Planning and Transportation Regulatory Panel

Planning Applications and Related Development Control Matters

AMENDMENT REPORT

APPLICATION No: 19/74484/REM
APPLICANT: C/O Agent
LOCATION: Land To The West Of , Michigan Avenue, Salford, M50 2GY ,
PROPOSAL: Details of reserved matters for access, appearance,
landscaping, layout and scale for a residential-led development
comprising of 1,298 apartments and 16 townhouses (use class
C3) and 1423sqm of commercial floor space (use classes A1,
A2, A3, A4, A5, B1, D1 and D2) with associated works, pursuant
to outline planning permission 18/72756/OUT
WARD: Ordsall

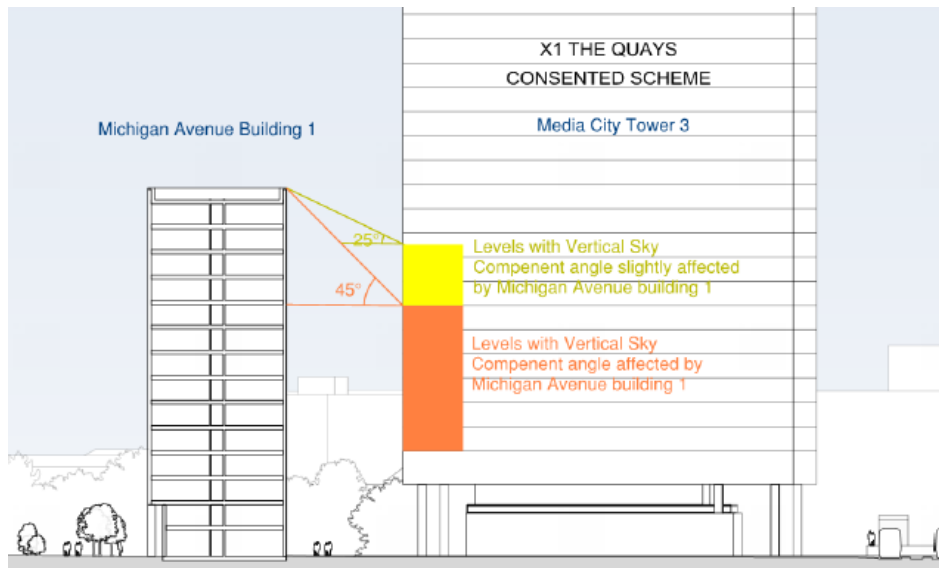
The new information assesses the VSC for the north apartments within the X1 development Towers 3 and 4 which are currently under construction. As discussed in the officer report there are four apartments per floor across these two towers which face the application site. The new information considers that only two apartments of the four per floor, will be impacted upon, as the other have alternative windows in either the east or west elevation.

The image below is taken from the daylight report submitted and shows the relationship between the two buildings and the level of apartments which are impacted on the VSC angle.

This exercise shows that the development will have an impact upon the daylight received into 12 apartments across towers 3 and 4, shown orange above. In respect of the apartments with a VSC which sits between 25 and 45 degrees, shown yellow, these apartments benefit from large windows and building 1 in the proposed development is largely glazed. The report concludes, for these reasons that the yellow shaded apartments will have access to sufficient daylight. It is acknowledged that the apartments in question do not benefit from high levels of sunlight due to their orientation north.

No before and after ADF figures have been provided in respect of towers 3 and 4. However, the impacts are clear from the VSC information that the development will have a detrimental impact directly on the daylight received into 12 apartments within towers 3 and 4. This equates to 2% of the 550 apartments within towers 3 and 4. Given the low level of apartments impacted upon, being mindful of the urban context and the suitability of the site for high density development and that the layout of building 1 has been positioned to accommodate Michigan Walk, the benefits of the scheme clearly outweigh the amenity impacts on neighbouring future occupiers and as such no objections are raised to the development in this regard.
